LORSON RANCH EAST FILING NO. 1

STREET, STORM SEWER, AND POND CONSTRUCTION PLANS

SHEET NUMBER
C0.1

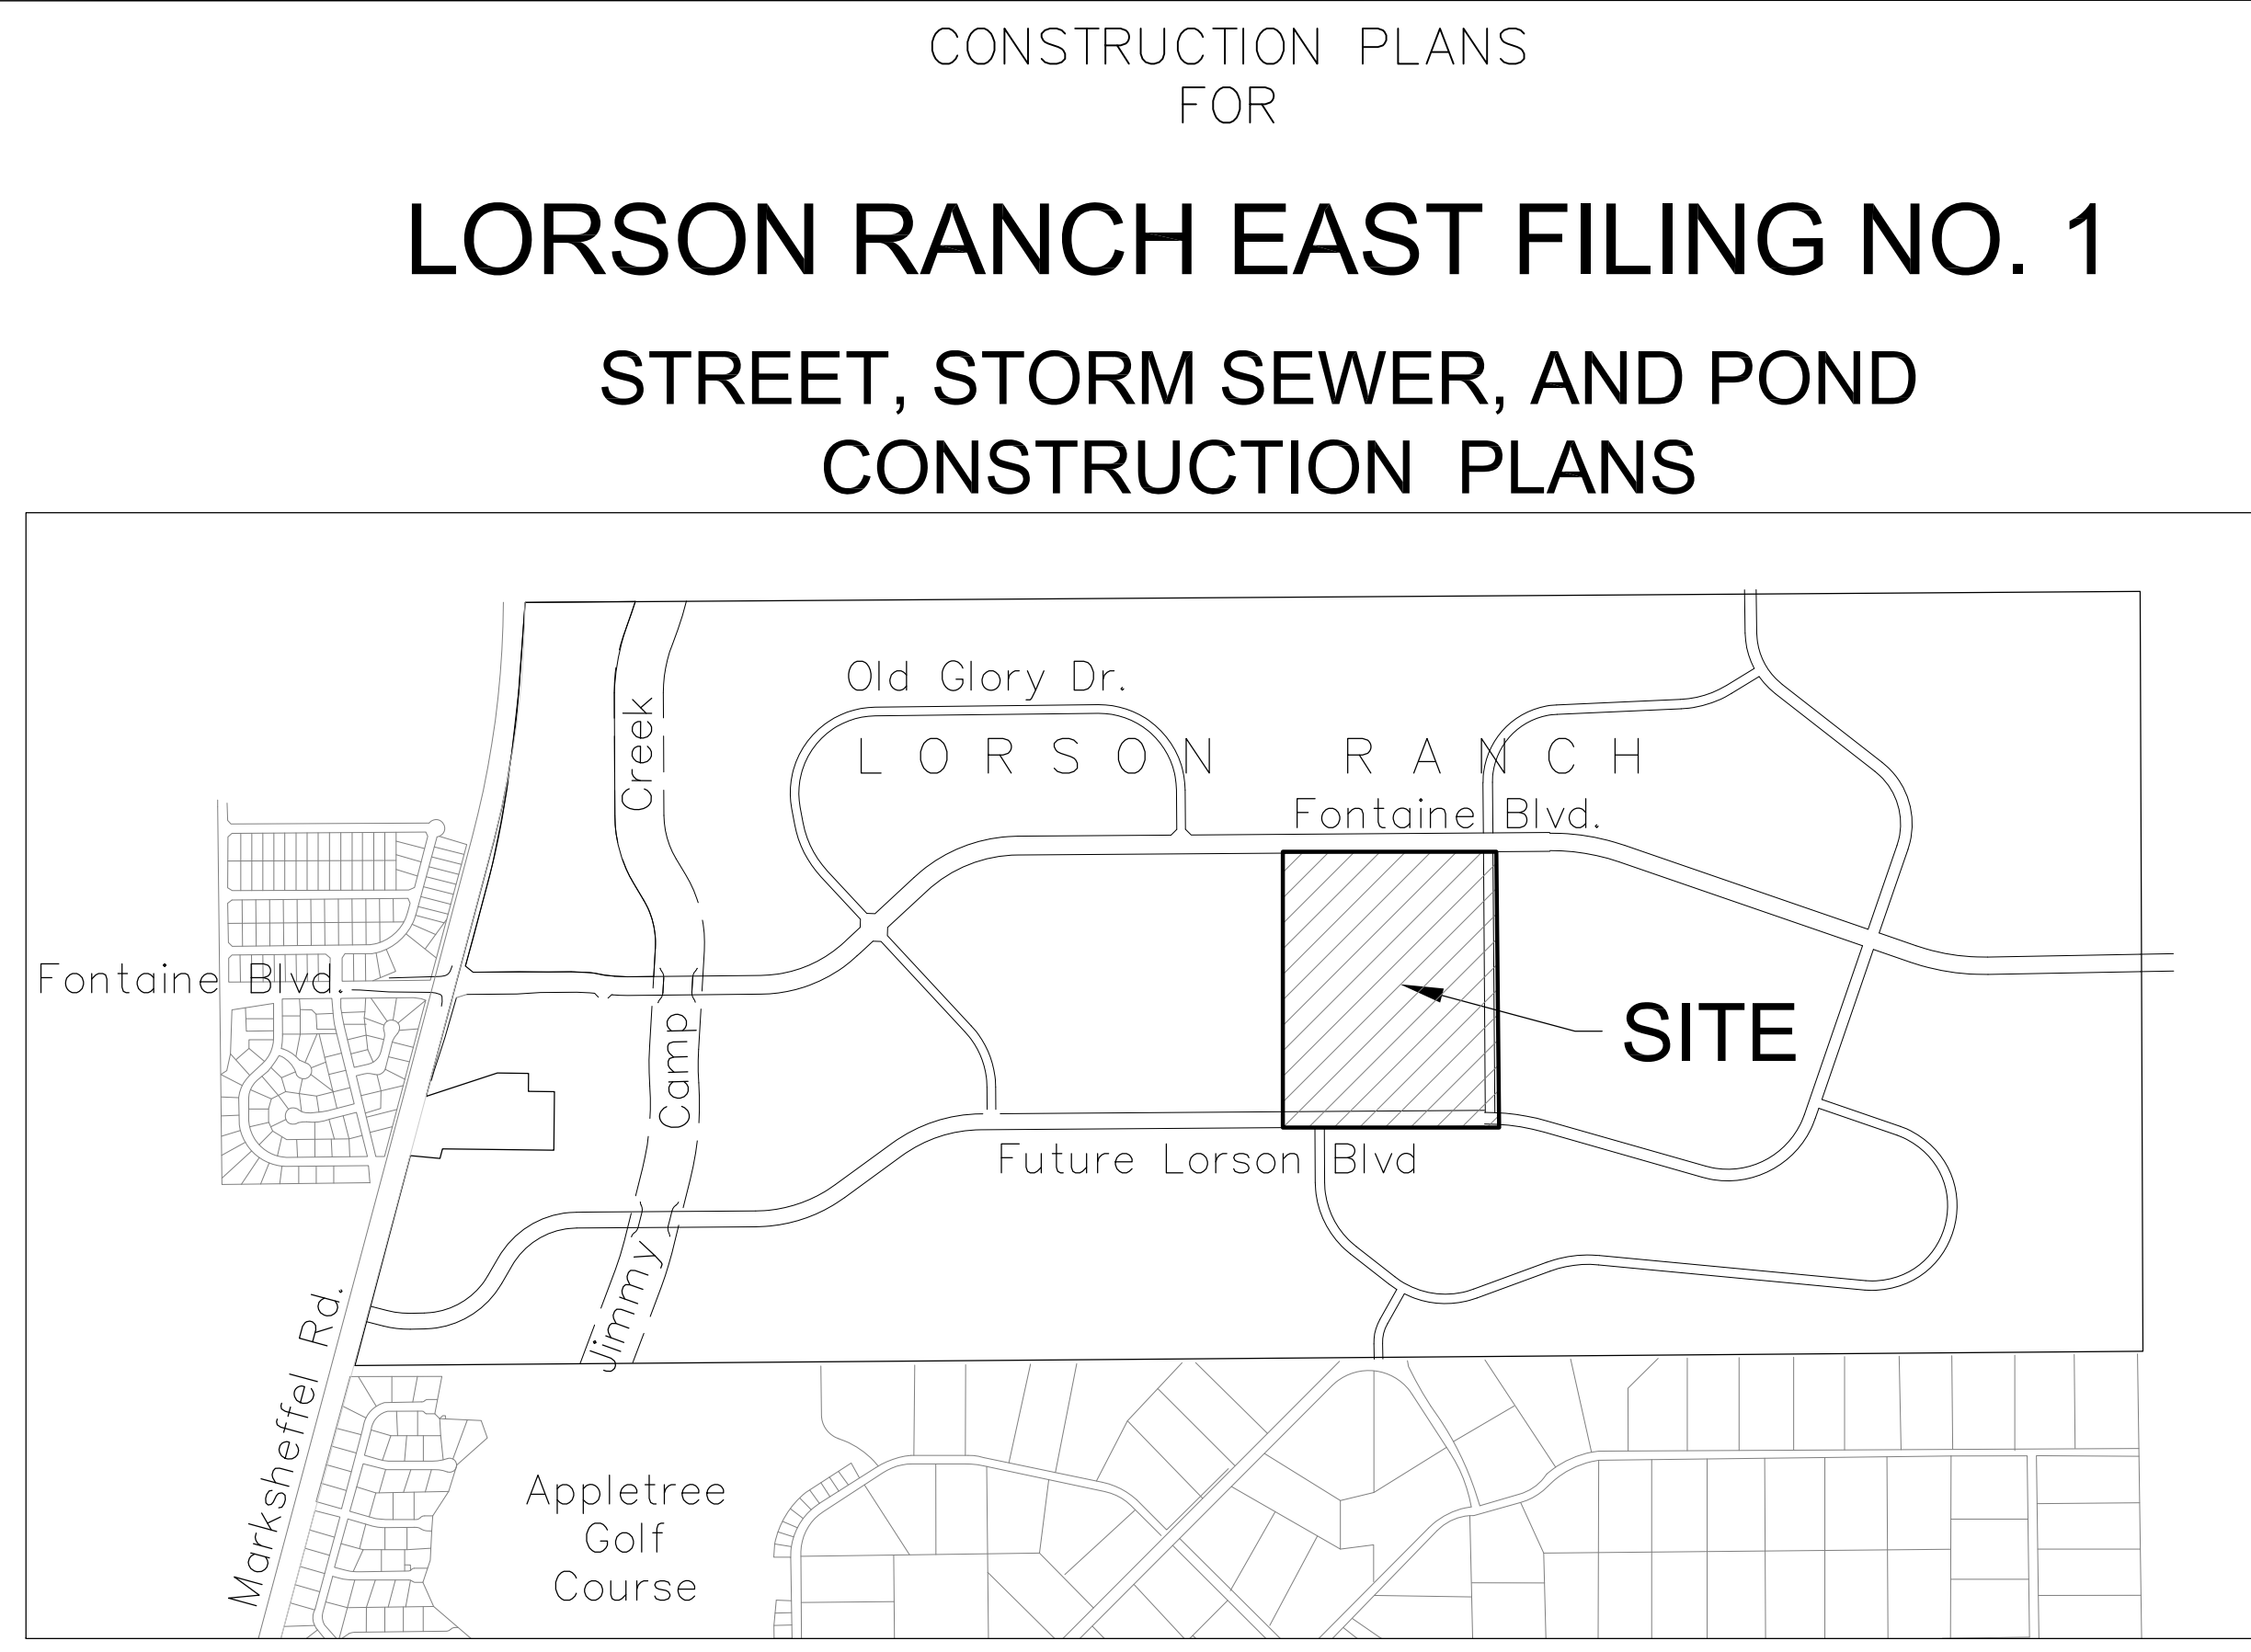
Replace with: "In accordance with ECM Section 1.12, these construction documents will be valid for construction for a period of 2 years from the date signed by the El Paso County Engineer. If construction has not started within those 2 years the plans will need to be resubmitted for approval, including payment of review fees at the Planning and Community Development Director's discretion."

LORSON RANCH EAST FILING NO. 1
SIGNING/STRIPING PLAN
LORSON BOULEVARD

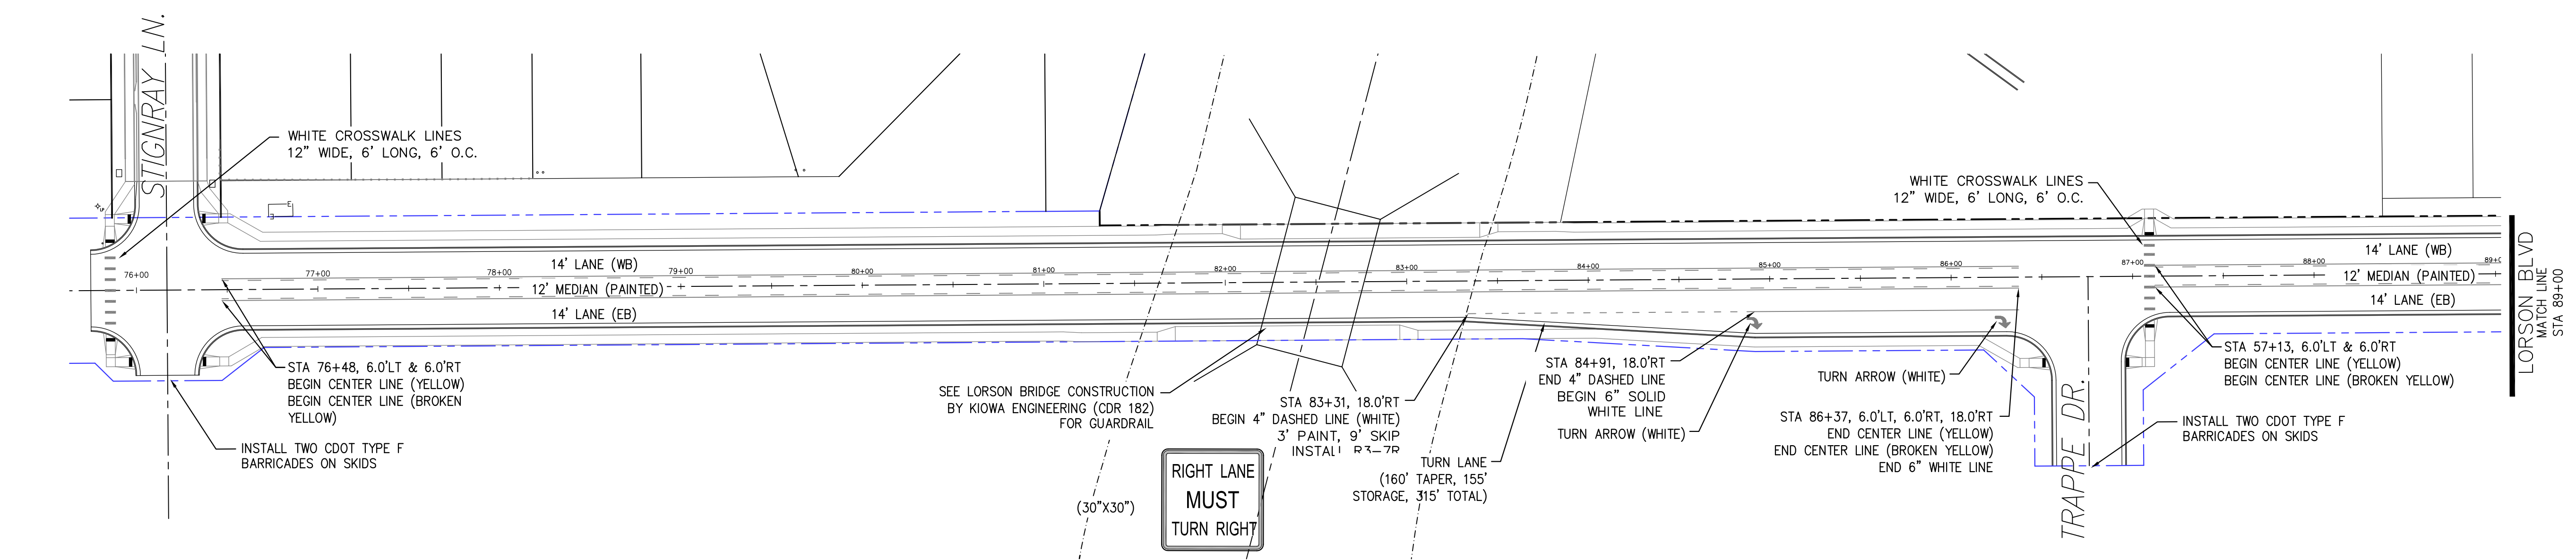
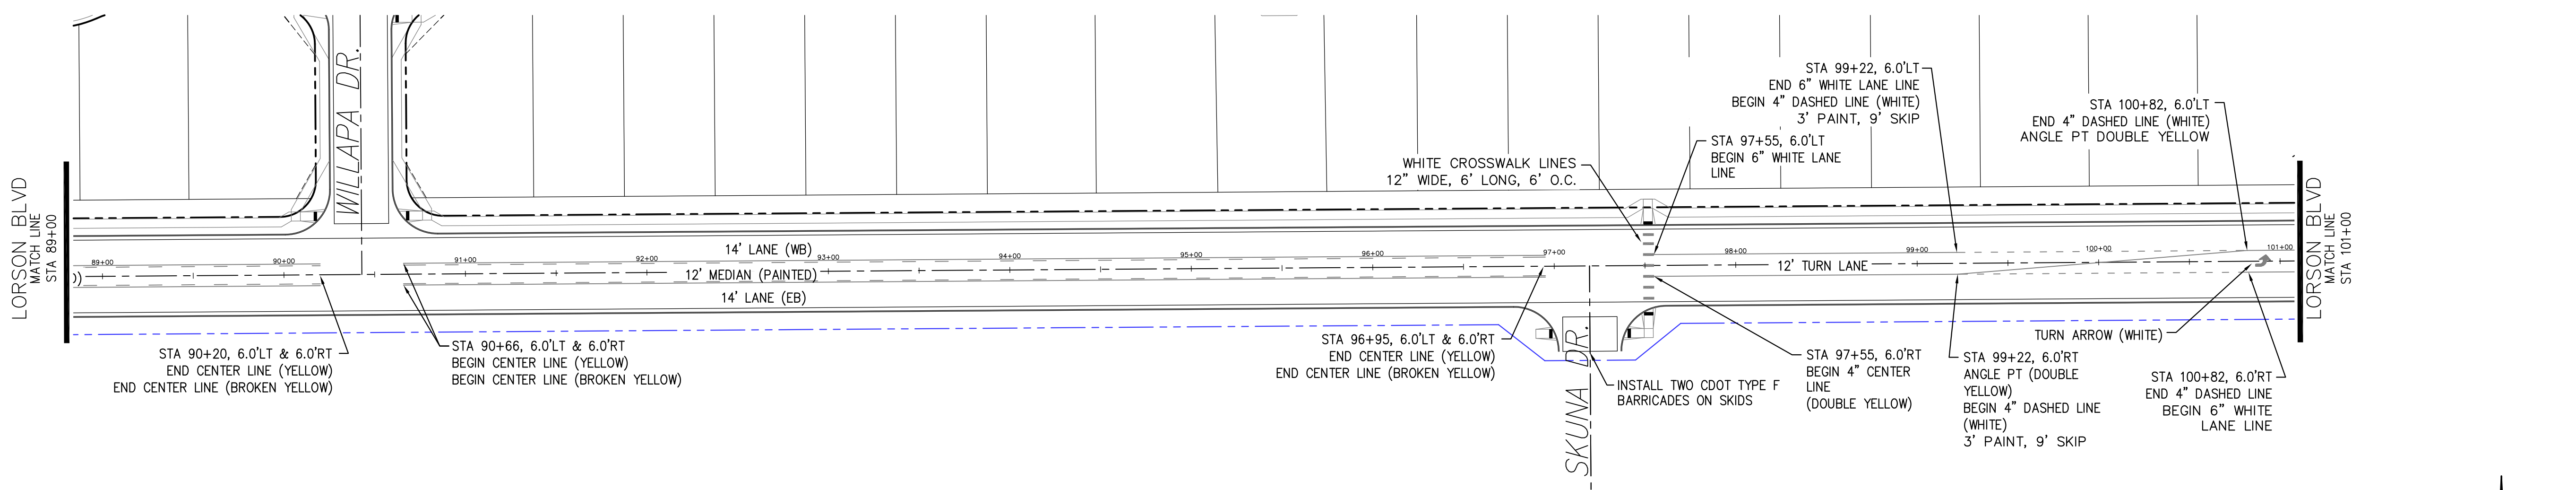
Adjust striping to show turn lanes, double yellow median striping.

LORSON RANCH EAST FILING NO. 1 SIGNING/STRIPING PLAN LAMPREY DRIVE

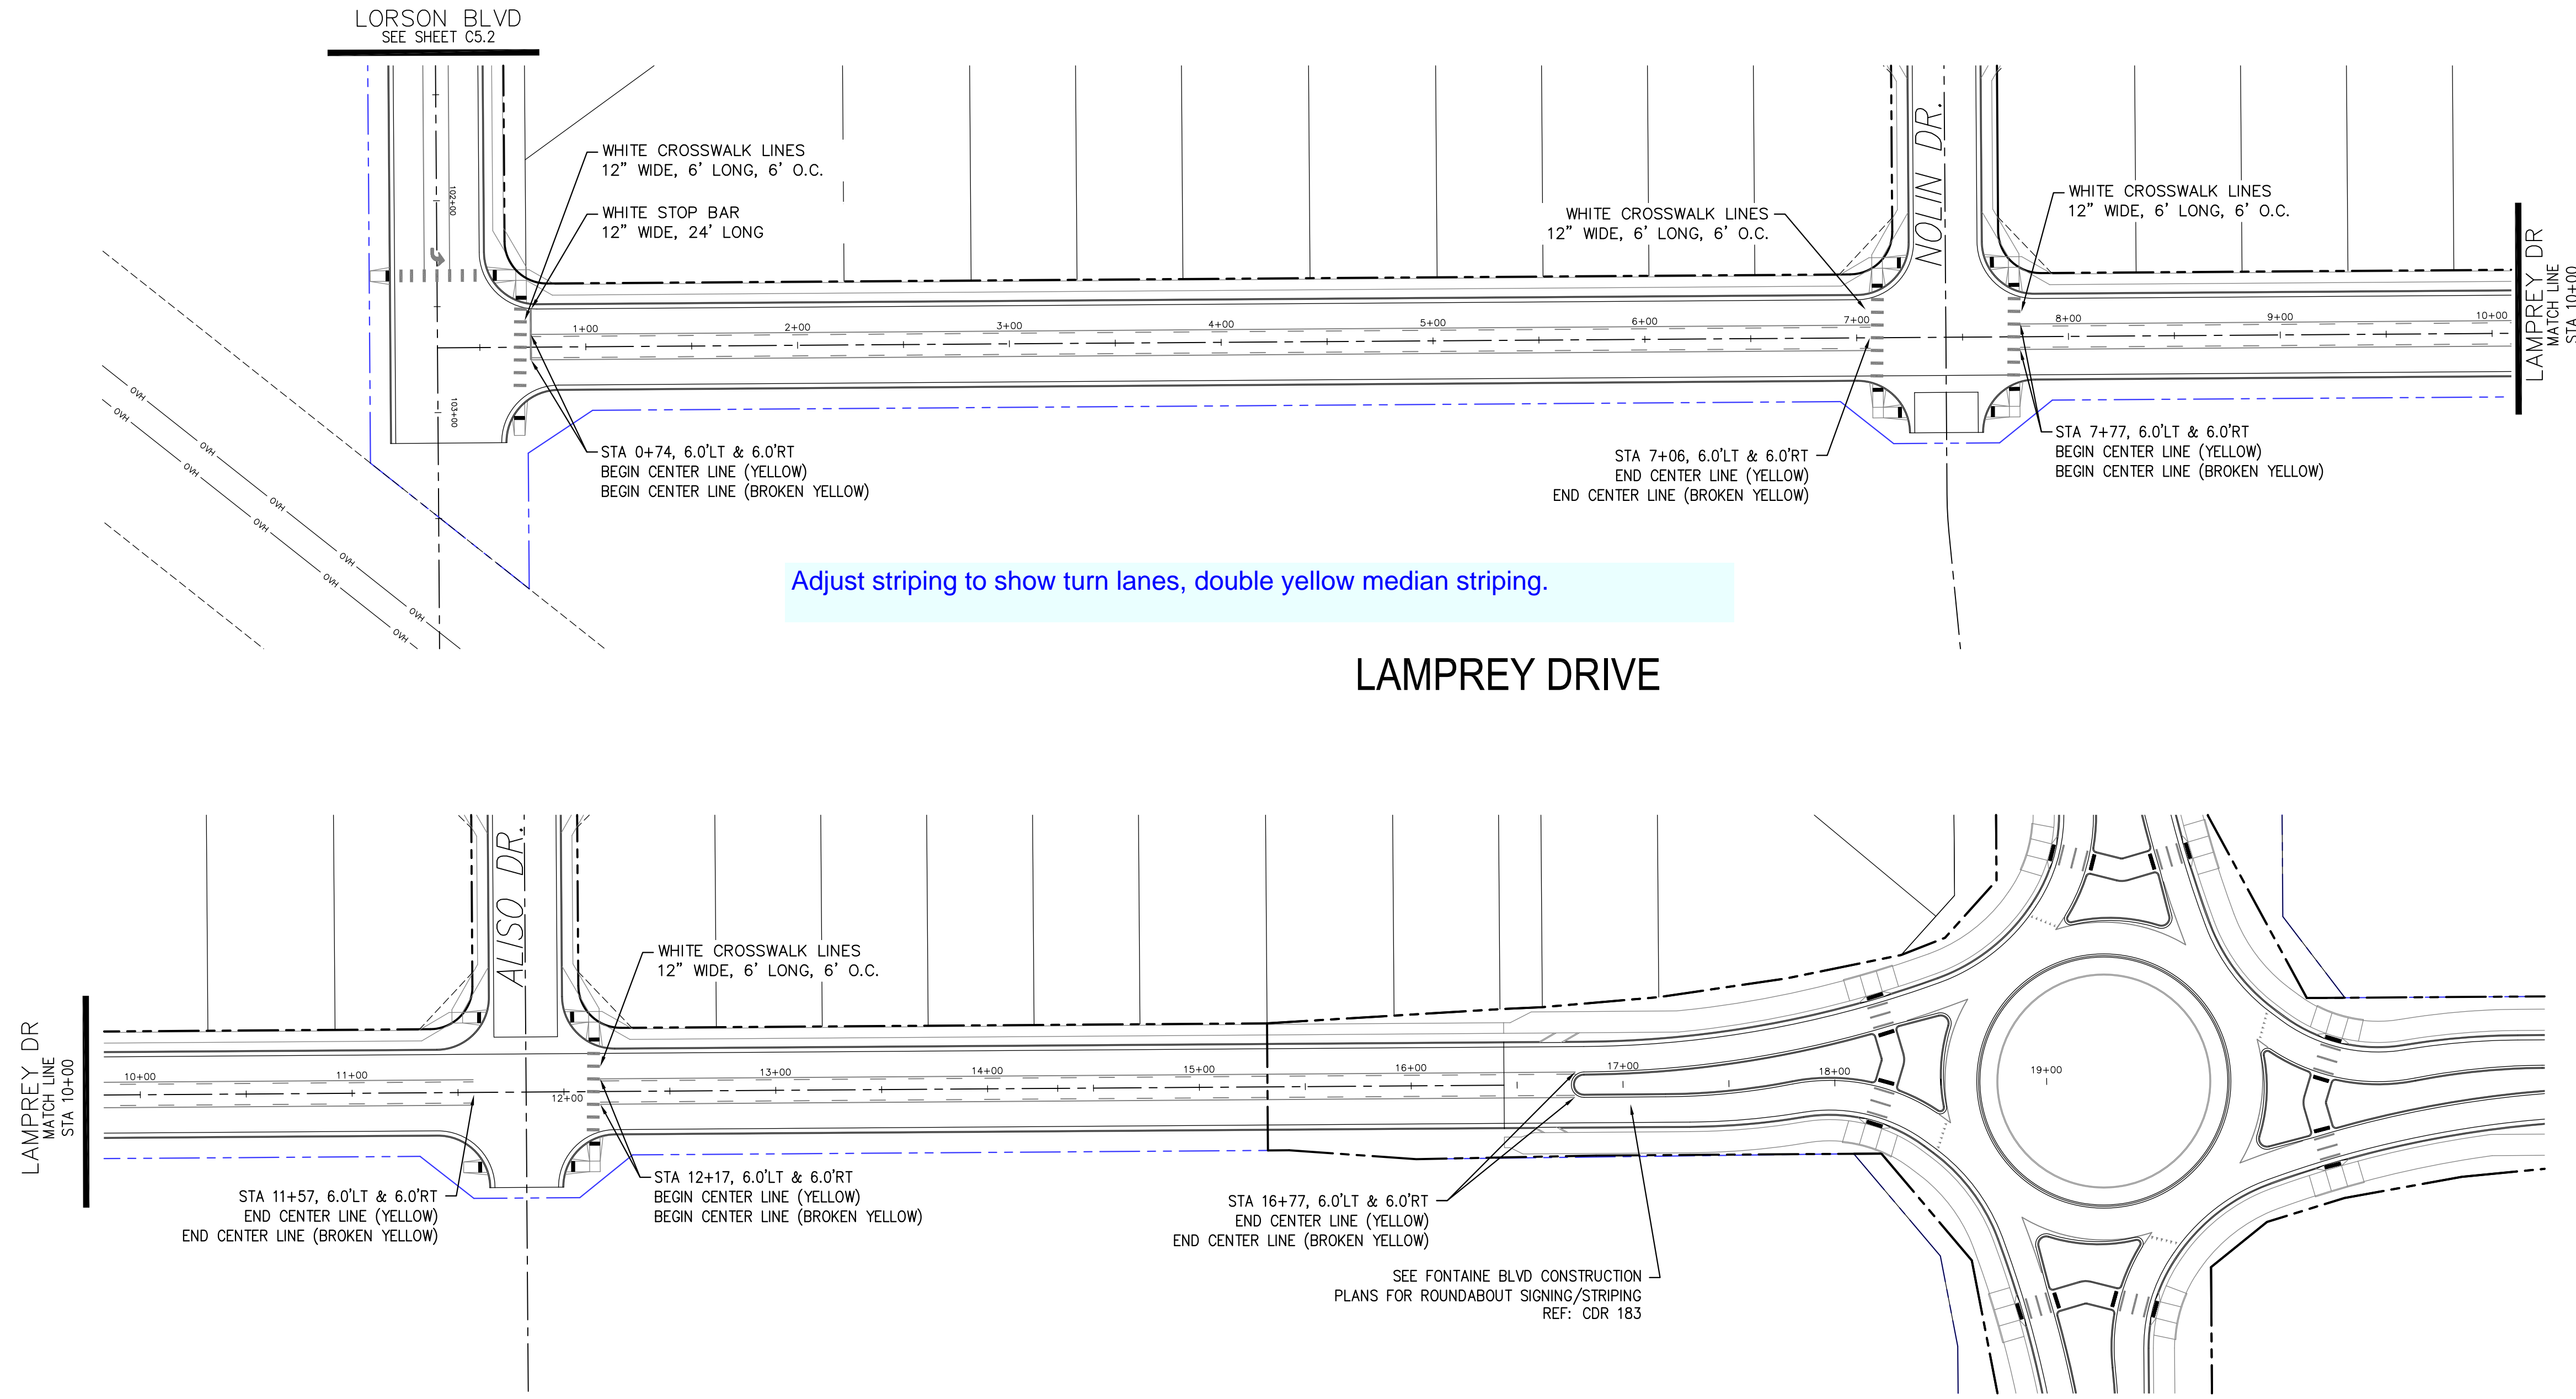
Adjust striping to show turn lanes, double yellow median striping.
